Approved For Release 2003/01/28 CIA-RDP78B04747A002900040050-2	STAT
TRANS	
Decree EVALUATION TYPED: 1 October 1963

- 1. This is a joint contract in which Navy BUWEPS will receive the third of three model viewers. Navy's unit will have digitizers added to permit measurement of pulses from the screw drives. Delivery to NAVPIC will occur 12 months from date of contract. The Model 552A is a considerably improved version of the High Magnification Direct Viewer, presently in operational use at NAVPIC. Essentially, it provides the capabilities requested in DO-315-RD64-1, Design objectives for the High Magnification Stereo Viewer, recently completed at NAVPIC.

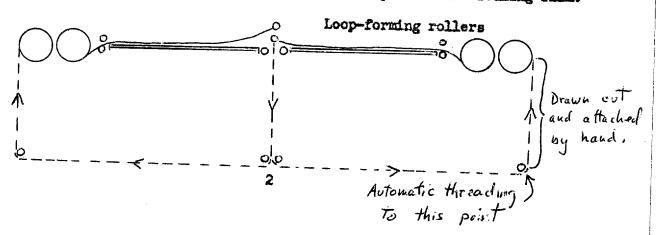
f. Construction.
	(1) Take-up spools for dual roll mode of operation, originally planned to be low on the sides of the instrument, have been moved up near the supply spool position for easier loading, thus increasing the loop length from spool-to-spool from 8 feet to 11 feet. (See figure on page 2)
